Reference: 21/00031/VARCON

Re: London Luton Airport, application to vary conditions 8 (passenger cap) and 10 (noise contours)

File Ref: A11060.03 N08

Subject: **Comparison of Contours for 2028 19mppa**

First Contour – Green

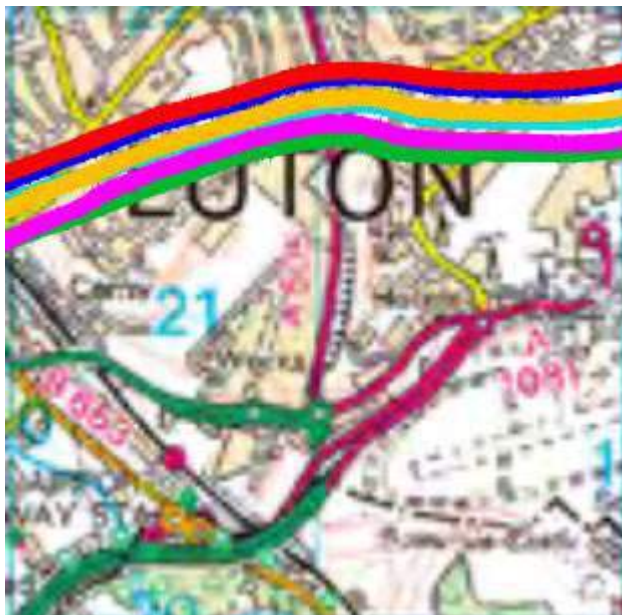
The first comparison is the southwest lobe. This shows the first contour ending before the wood near Cotton Spring Farm whereas the second extends beyond it. The change in width is also visible, using the name Markyate as a guide the first contour splits the 'a' and 'r' while the second contour goes through the left hand side of the 'M'. On the other side, the first contour just passes outside the 'm' of Rainbow Hall Farm while the second of some distance to the east. The second contour is therefore both longer and wider in this area.

First Contour – Green

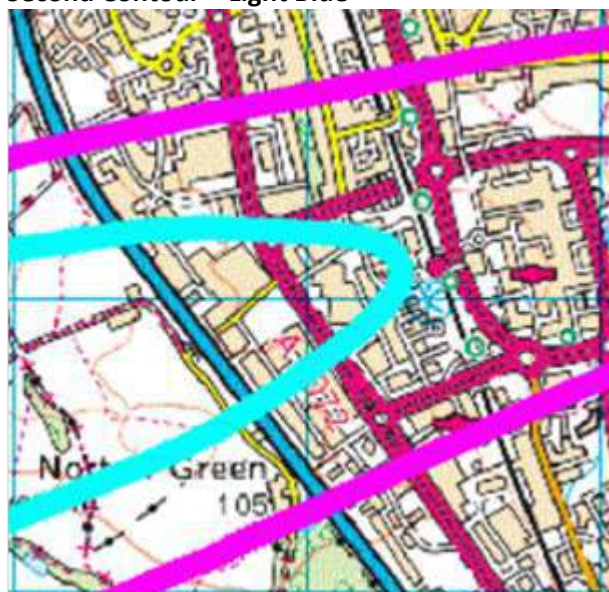
The second comparison is the area to the north west of the airport. The change in width remains visible, using the name Luton as a guide the first contour is close to the bottom of the 'L' and goes through the top of the 'T' and 'O', while the second contour goes through the top of the 'L' and is above the other letters. The second contour is therefore wider in this area.
